GEORGE M.  
JANES &  
ASSOCIATES

RE: Comments related to Silo Ridge's  
February 19, 2015 submission

I have reviewed portions of the application for the Silo Ridge Resort Community submitted on February 19, 2015. The primary focus of this letter relates to the applicant's responses to my October 10, 2014 comment letter (which is Volume 5, Section 3.4 of the February submission,) as well as portions of the application that impact the visual resources of the area.

**Figure 2: 2014 plan showing which buildings are visible in the visual simulations.**

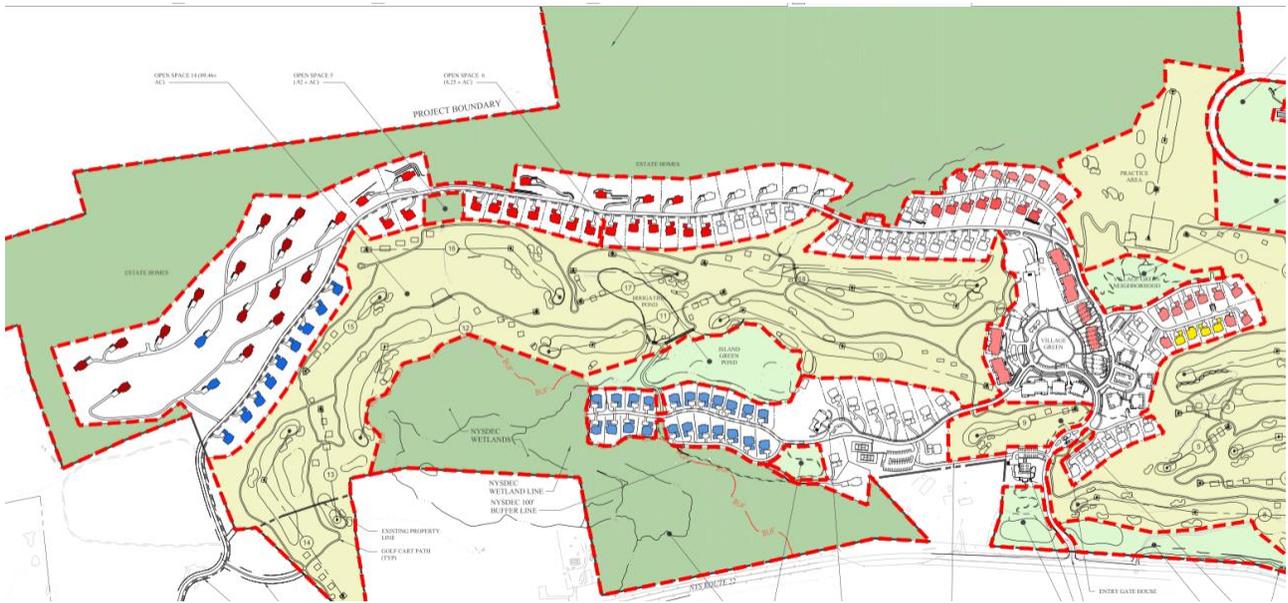
The visual simulations show that about 35% of the buildings are not visible from the viewpoints analyzed, which is quite a difference from the 78% claimed in the MDP. There have been significant changes in the plan in the Estate Home area, but these changes are unlikely to make any of these buildings not visible from public areas due to their elevation high above the valley floor.

Further, the visual simulations only represent a handful of important viewpoints. The zoning compliance section of the MDP makes this visibility claim from any “public place.” A viewshed map testing visibility from all public lands and roadways could only show more buildings with visibility.

For its decision-making the Planning Board should ignore the 78% statistic found in the MDP, and rely upon the visual simulations for understanding the project’s impact on the Town’s visual resources. That said, whether it be 35%, 78% or some other number, I do not believe that this statistic is material to showing compliance with the Town’s SPO.
